## ATTACHMENT 2

### D3C10 Evaluation of Significant Hazards Consideration

Commonwealth Edison proposes to amend Facility Operating License DPR-25 for Dresden Unit 3 to allow the use of Exxon 9x9 fuel, operation of the reactor in an expanded POWER/FLOW region and allow Single Loop Operation above 50% thermal power for Cycle 10.

Figure 3.5-1A  
LINEAR HEAT GENERATION RATE VS.  
NODAL EXPOSURE

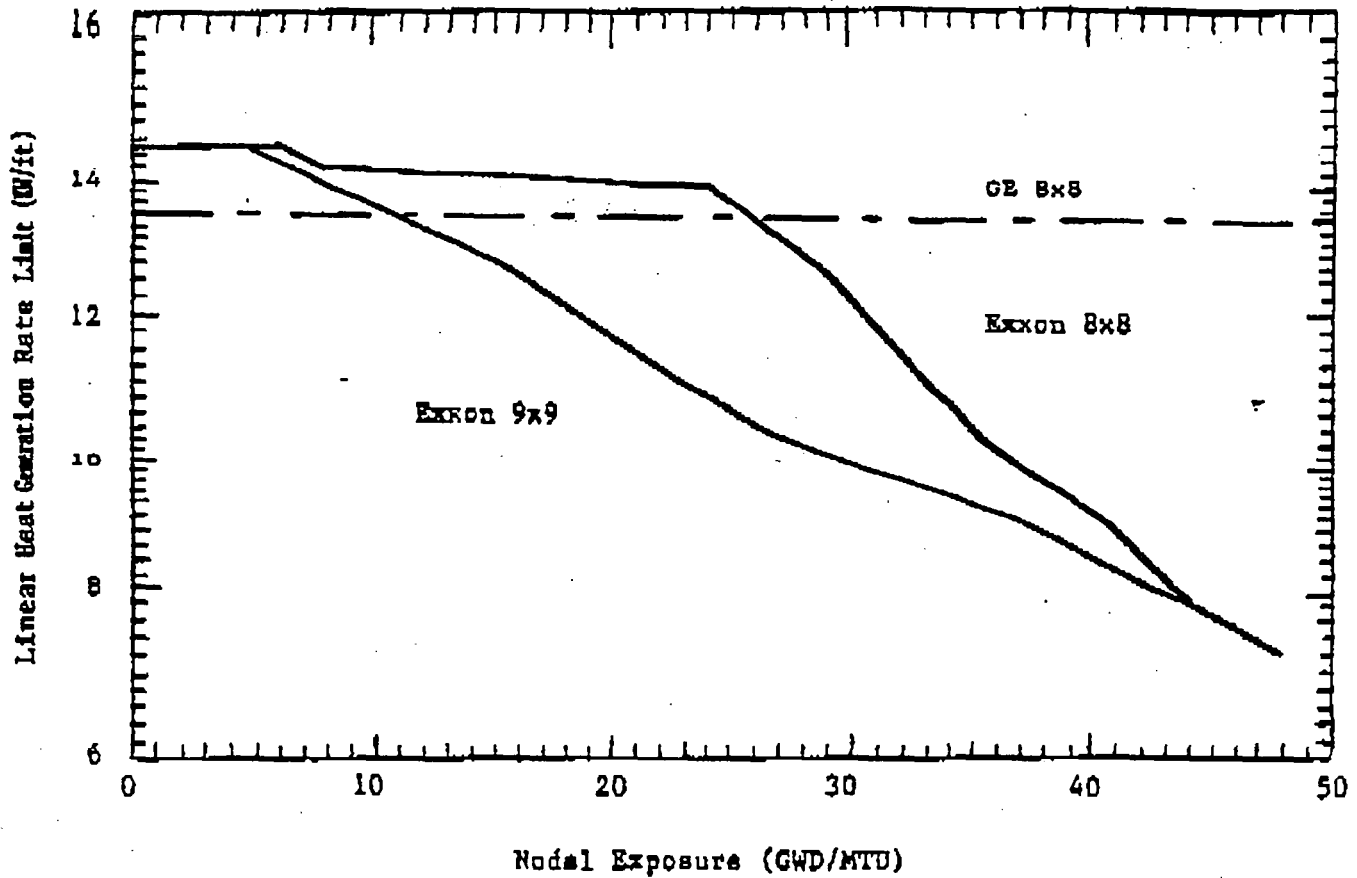
at any axial location shall not exceed its maximum LHGR value shown in Figure 3.5-1A (consists of three curves).

Figure 3.5-1A depicts the LHGR values for Exxon 8x8 and 9x9 fuel as a function of nodal exposure and for GE 8x8 fuel as a constant design value of 13.4 Kw/ft.

FIGURE 3.6.2

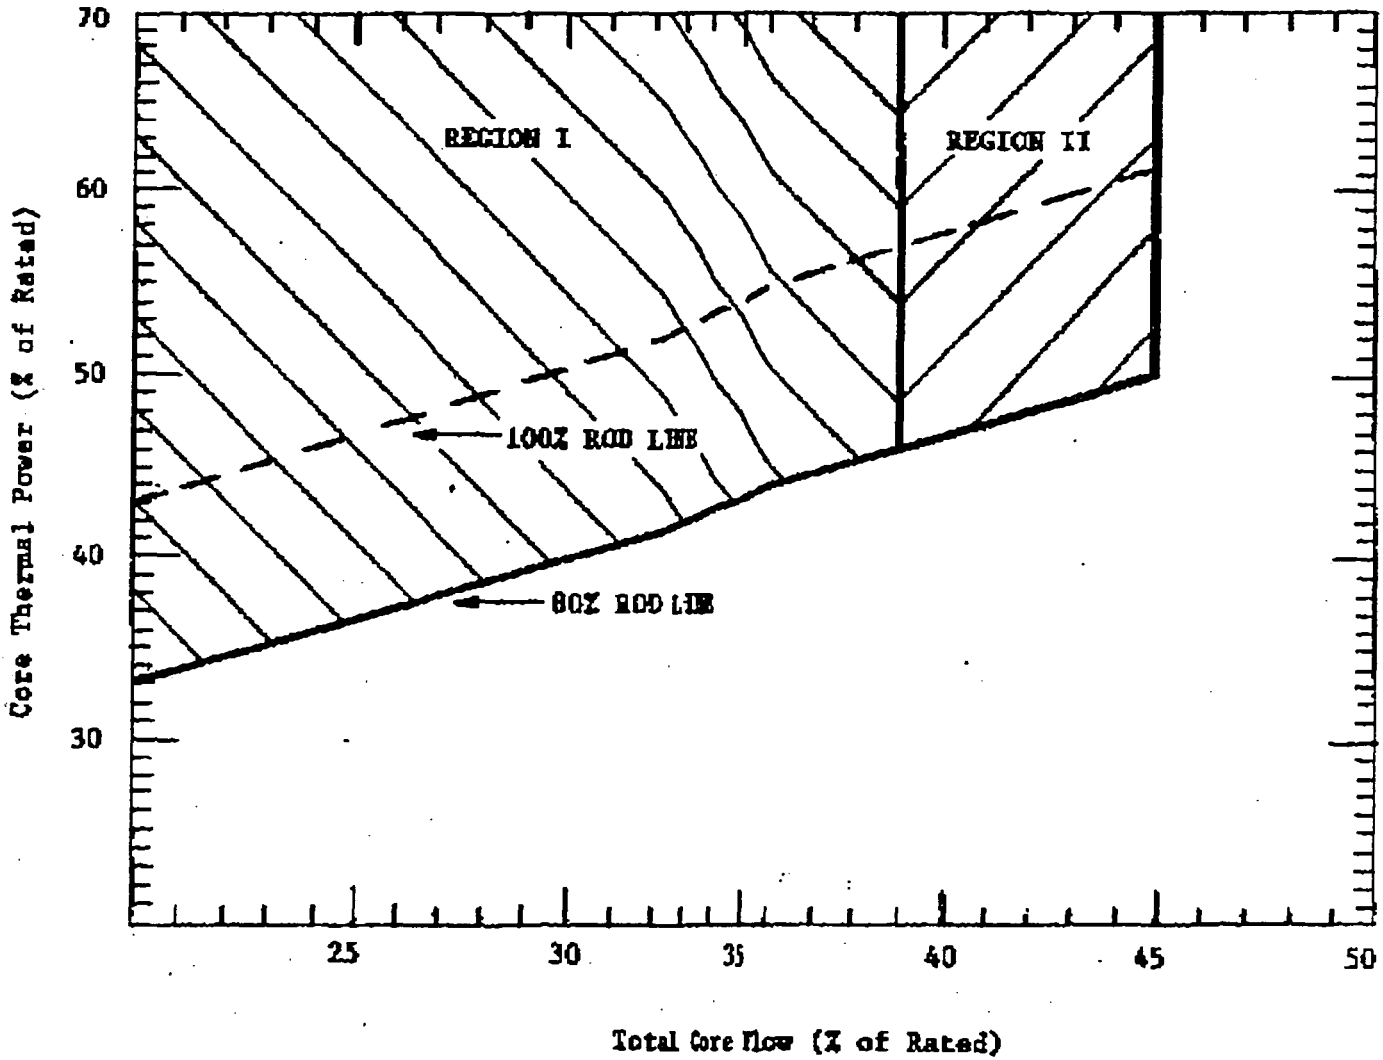
3. During Single Loop Operation, the following restrictions are required:
- a. Operation with the Master Flow Control in AUTO is not permitted;
  - b. Operation in Region I of Figure 3.6-2 is not permitted. Initiate action immediately after entering Region I and be outside of Region I within 2 hours.

- c. Operation in Region II of Figure 3.6-2 is permitted provided that:
  - i. Baseline data has been acquired per specification 4.6.H.3.a;
  - ii. If baseline data has not been acquired per specification 4.6.H.3.a., immediately initiate action to be outside Region II within 2 hours;
  - iii. Stable reactor operation is verified per specification 4.6.H.3.b.; and
  - iv. If stable reactor operation cannot be verified per specification 4.6.H.3.b., immediately initiate action to restore stable operation within 2 hours.
- d. The operable recirculation pump shall be at a speed less than 65% of rated before starting the inoperable pump;

Regions I and II of Figure 3.6.2 represent the areas of the power/flow map with the least margin to stable operation. Although calculated decay ratios at the intersection of the natural circulation flow line and the APRM Rod Block line indicate that substantial margin exists to where unstable operation could be expected. Specifications 3.6.H.3.b., 3.6.H.3.c. and 4.6.H.3. provide additional assurance that if unstable operation should occur, it will be detected and corrected in a timely manner.
